22 January 2016

CAA DECISION LETTER

INTRODUCTION OF GIRLI 1X SID and OMNI departures at NEWCASTLE AIRPORT

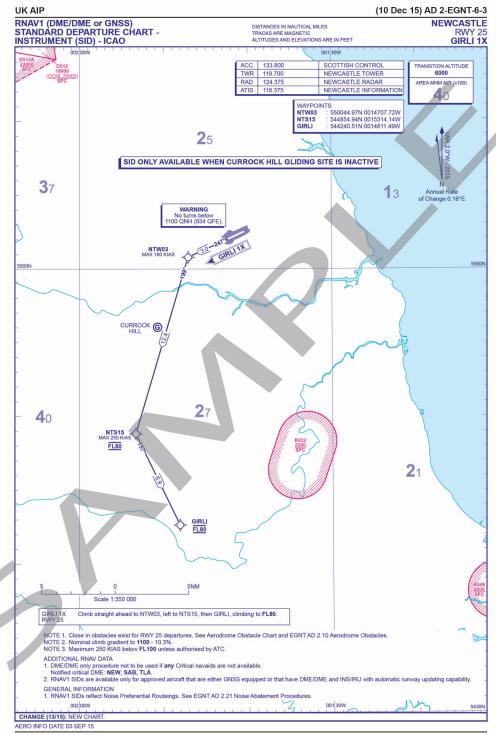
SIDs must terminate at a significant waypoint on an ATS route at either an existing waypoint or (if required) a new waypoint. One of the proposed SID designs (GIRLI 3X), whilst complying with the NPR, did not reflect where traffic is currently positioned. Although it was acknowledged that traffic on this proposed SID would continue to be tactically positioned where it flies today, this was inconsistent with Consultation material and therefore, could not be supported by the CAA.

The revised design of the GIRLI 3X SID whilst not totally in line with what was consulted upon more accurately reflects the design proposed in the ACP and what has been flown for the last 15 years and what will continue to be flown. It also builds in a level restriction of 7000ft at waypoint NTS15 which effectively makes the final portion of the SID redundant and the portion below 7000ft that is likely to affect communities on the ground is in line with those who were consulted.

The now formally re-designated GIRLI 1X SID will be wholly contained within existing Class D airspace and allow Operators to flight plan the SID onto ATS Route P18. It is acknowledged that depending on the fuel loading programme and policy of an individual Operator, the fact that there is now a specific flight level (FL80) assigned to waypoint GIRLI when hitherto there was none, this may slightly increase fuel uplift. It is not possible to

Traffic departing on the GIRLI 1X SID will continue to be vectored by Newcastle Radar towards the west side of ATS Route P18 once they have passed between Throckley and Heddon-in-the-Wall and are clear of the Currock Hill gliding site which replicates the procedures applied today.

The GIRLI 1X and OMNI departures are supported by many stakeholders and will contribute to enabling the airport to progress with its aspirations and systemisation. I have therefore decided that, following the re-design of the proposed GIRLI 3X SID and now redesignated as GIRLI 1X, to approve this SID and the OMNI departures that formed part of the original Airspace Change Proposal for operational use on the strict understanding that the final leg of the GIRLI 1X SID between waypoints NTS15 and GIRLI shall **not** be flown except for reasons of operational flight safety such as separation or weather avoidance.
